### **REMARKS**

PATENT  
Serial No. 09/876,742  
Attorney Docket No. 450100-03274

FIG. 8

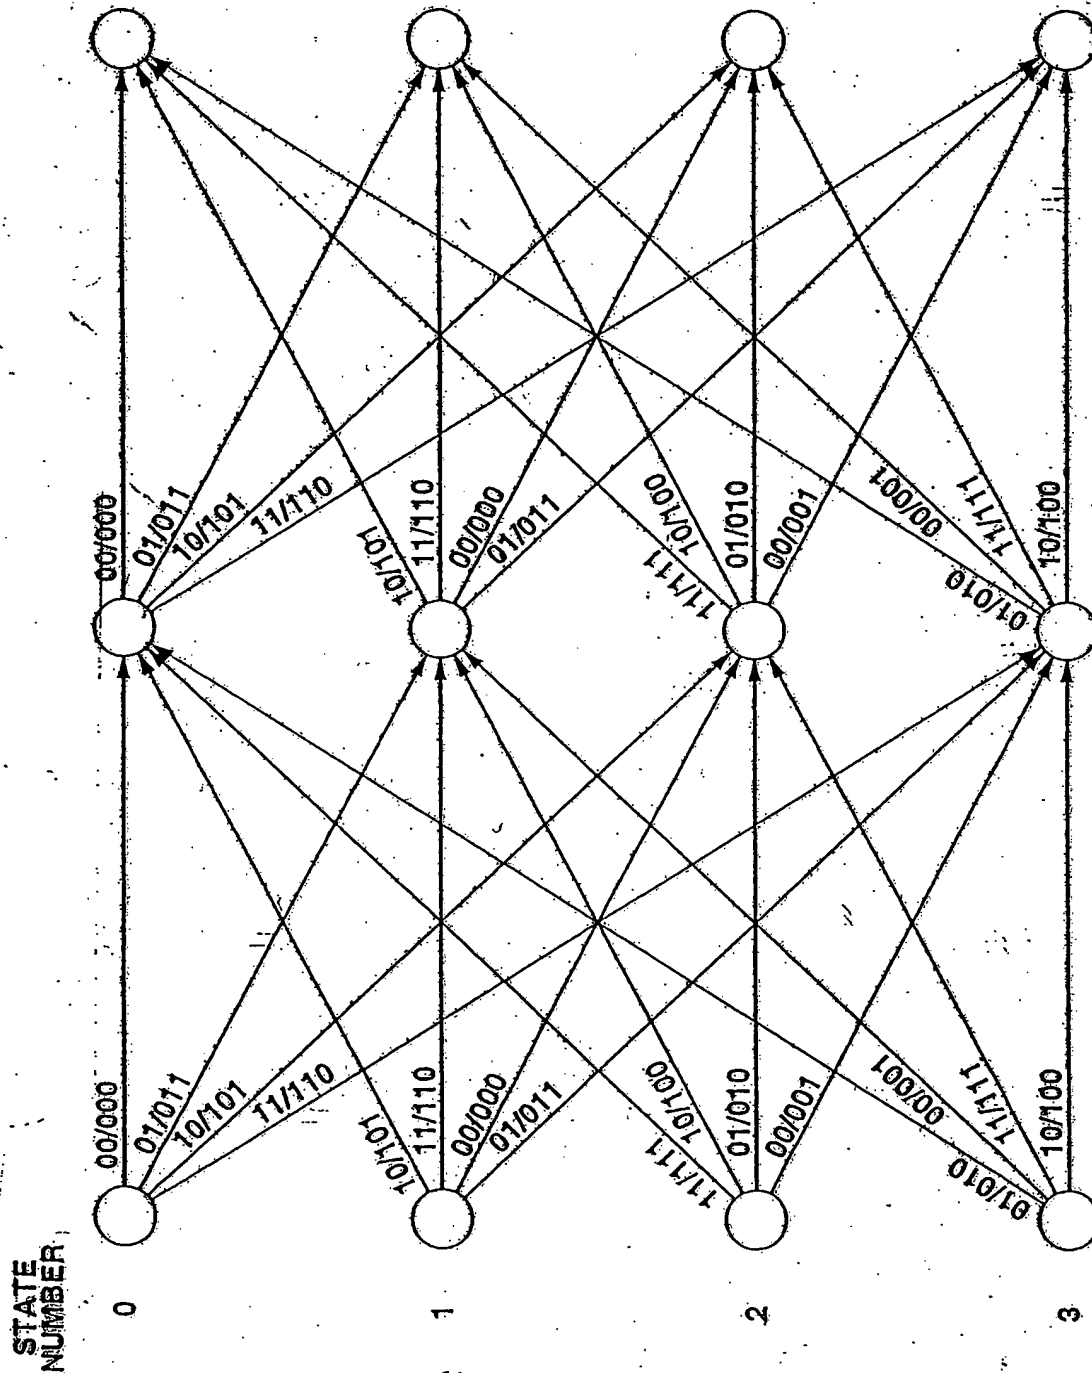
In Section 1 of the Office Action, the Examiner has objected to Figure 8 for failing to indicate it as being Prior Art. Figure 8 has been amended, obviating the objection. Accordingly, it is respectfully requested that this objection be withdrawn.

(PRIOR ART)

legend added
